Abnormal "Squeak" Noise From Rear Suspension Over Uneven Roads

Applicability

| YEAR(S) | MODEL(S) | ADDITIONAL INFORMATION |
|-------------|---------------------------|------------------------|
| 2014 - 2017 | Highlander, Highlander HV | |

Figure 1.

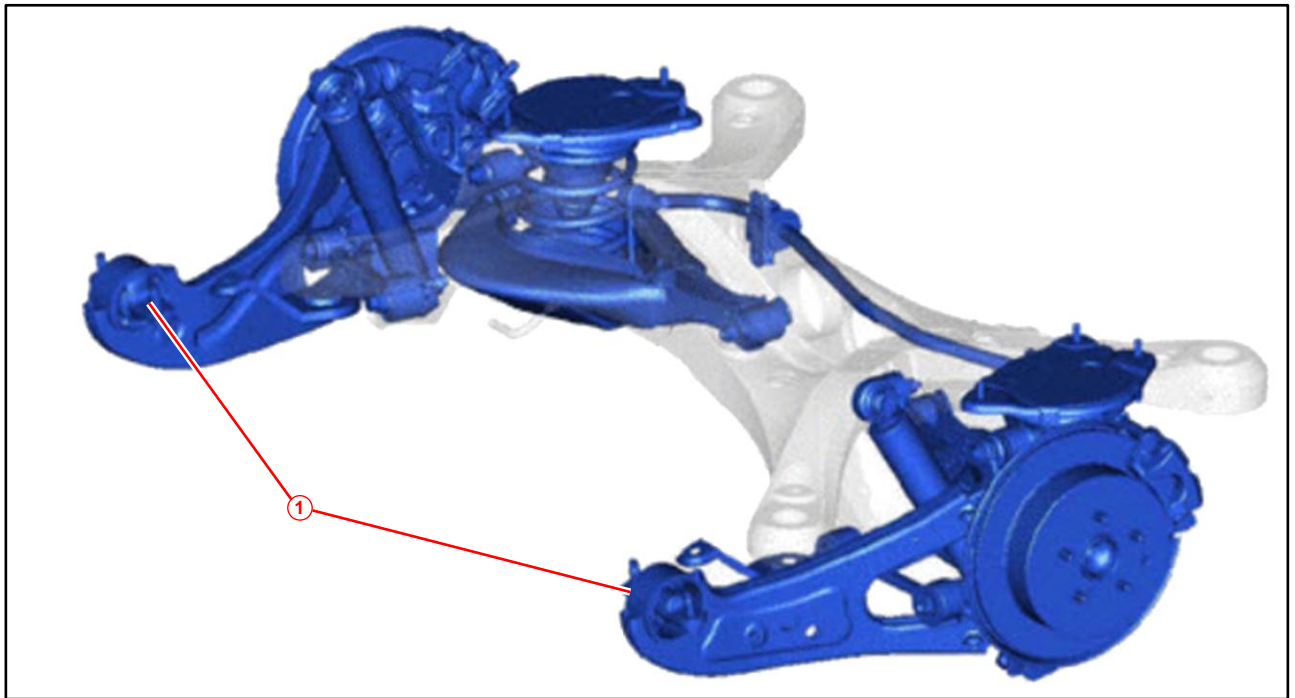
Some 2014 – 2017 model year Highlander and Highlander HV vehicles may exhibit an abnormal squeak, squawk or groan type noise from the rear suspension when traveling over uneven roads, or when the vehicle comes to a complete stop, which may become more pronounced in colder ambient temperatures. The abnormal noise may be caused by the rear trailing arm bushing. An updated Rear Trailing Arm Assembly is available. Follow the Repair Procedure in this bulletin to address this condition.

| PART NUMBER | | PART NAME | QTY |
|----------------------------|-------------|---------------------------|-----|
| 48760-0E050 48760-0E051 | 48760-0E070 | Arm Assy, Trailing, RR RH | 1 |
| 48780-0E060 48780-0E061 | 48780-0E080 | Arm Assy, Trailing, RR LH | 1 |

Figure 2. LH Side

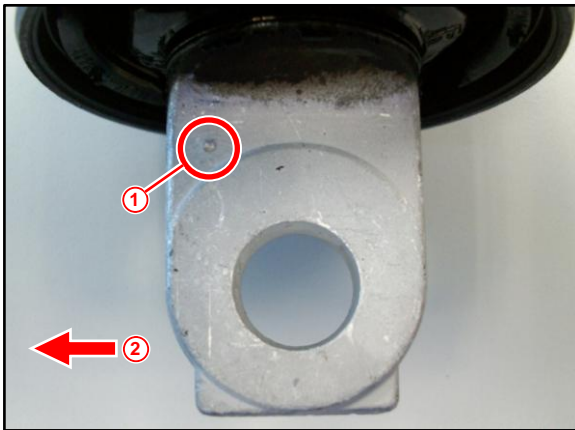
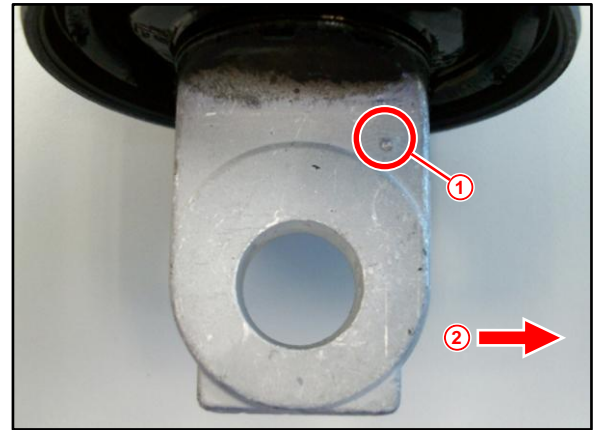
- BEFORE installing NEW parts, confirm the identification mark as shown. If this mark is NOT present, the part is incorrect and SHOULD NOT BE INSTALLED.

The identification mark on the NEW parts faces the outside of the vehicle.
